Delegated Report

Non-Material Amendment Application

Planning Application No: 20240806

Location: Former Ascot Arms Ascot Road Gravesend Kent

Proposed Tree Plan

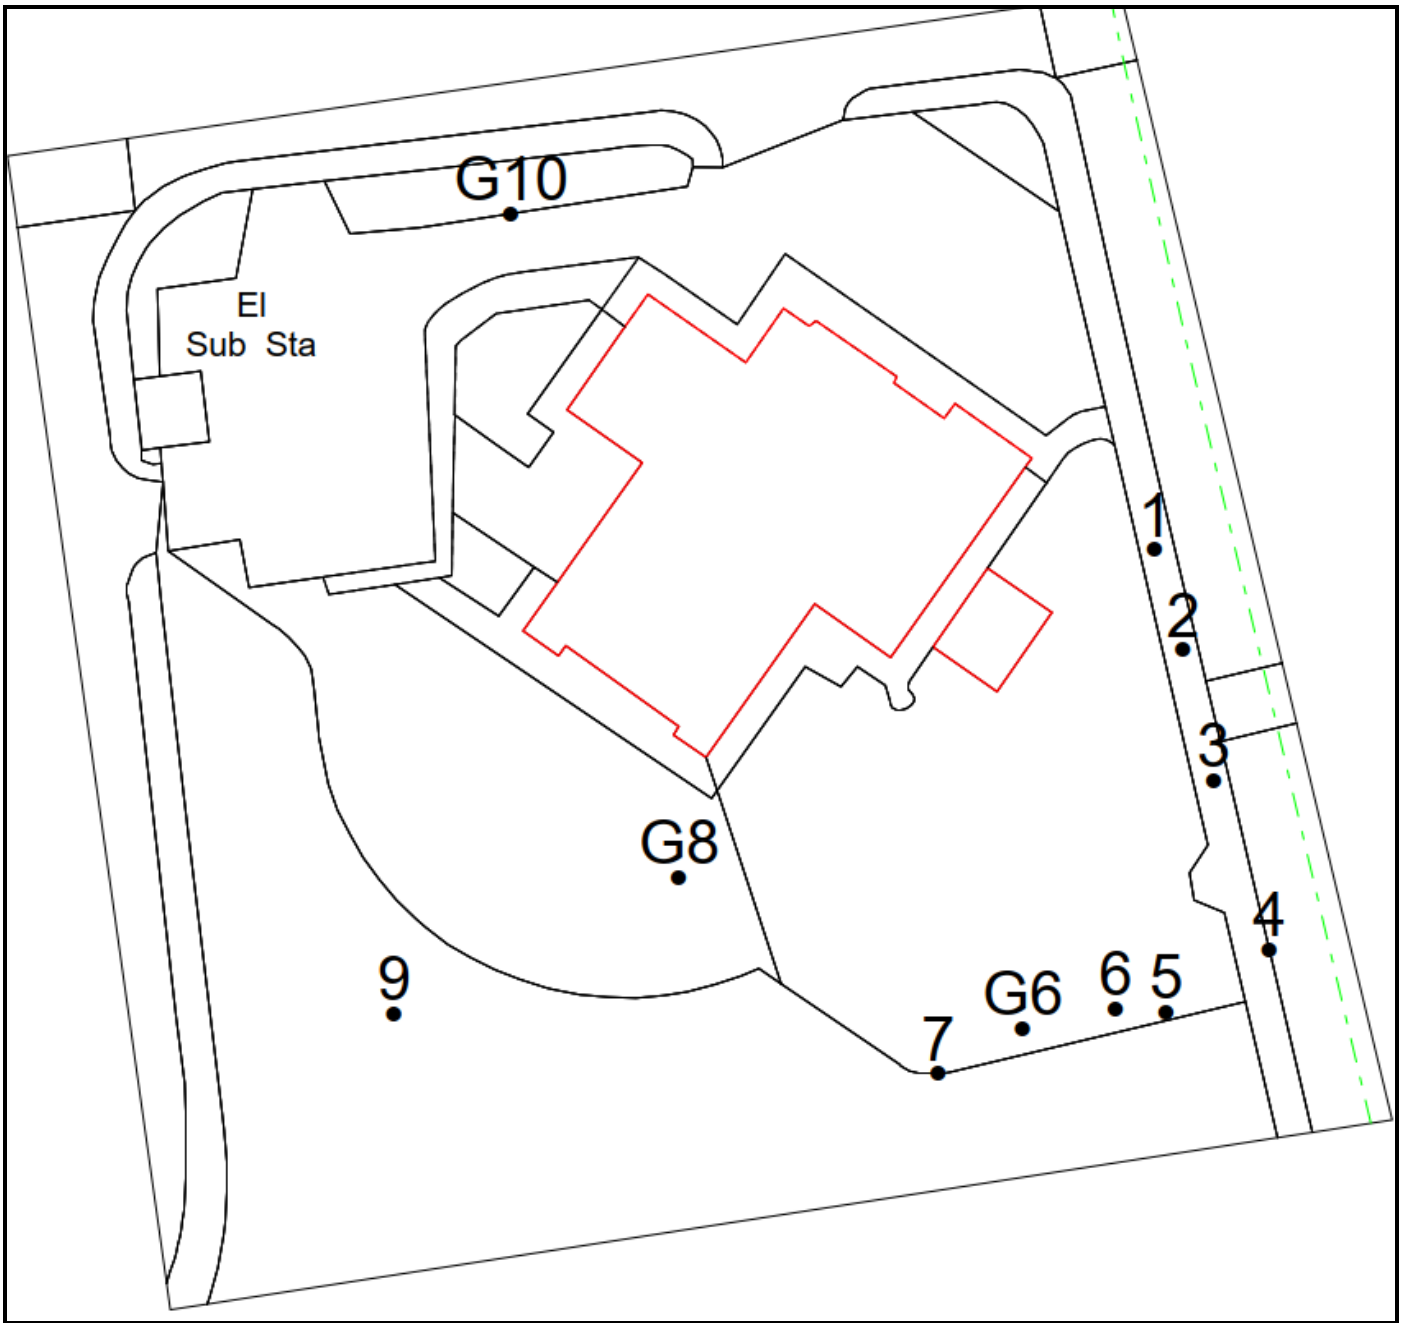
This application seeks to replace the approved arboricultural report and tree works proposals. As a number of trees are involved, the below table collates the information obtained from the approved tree documents, the proposed and written clarifications provided by the planning agent and arborist. is used to indicate the changes presented in the updated information from the previous. The tree tags have also been altered and so are confirmed for comparison purposes.

As the table above shows, the main changes presented by the submitted information would relate to the addition of a tree not previously surveyed (New tree tag T9). A number of trees previously agreed to be removed have now been removed and so are not included in this document, but are confirmed in the table above for completeness (Originally Tree tags G1, T1, T5, T6, T10 and part G2). Original Tree tags T6, T7 and T8 are not included on the new tree documents but the planning agent has confirmed that the proposals to those trees would remain unchanged and as per the original approval. Original Tree tag T11 (now T4) would be removed as the arborist confirms that it has no chance of survival. This tree is a *Prunus avium* (Wild Cherry). The arborist has confirmed that the replacement species would be a *Tilia cordata* (size 14/16). This is a tree native to the UK suitable for urban environments. The nursery std of 14-16cm is also considered appropriate for this tree. This would therefore be a suitable replacement. Other changes proposed to recommended works on the trees relate to proper tree maintenance and care and are considered reasonably necessary and unlikely to result in significant deterioration of the tree structures or rooting areas.

It is considered that the above changes are non-material in relation to the scale and nature of the development and the application can be supported.
